Service Alert

Subject: TRANSMISSION DESIGN CHANGE (PART SUPERSESSION)	Service Alert No.: SA-002/24
	Last Issued : 01/10/2024

2024 CX-90 (H3T)

Original Design (Transmission Hole Drilled)

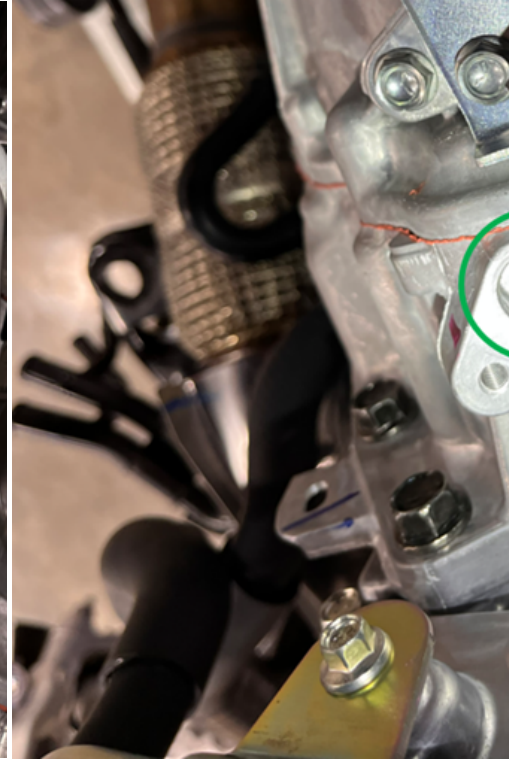
Due to a manufacturing change, the CX-90 transmission has undergone a transmission part design change when replacing the transmission assembly.

Old design originally required a coolant line running to the top of the bell housing, the new design has omitted the hole and need for the coolant line.

The new/superseded design can be used in place of the old/original design and the coolant hose is no longer needed to be used.
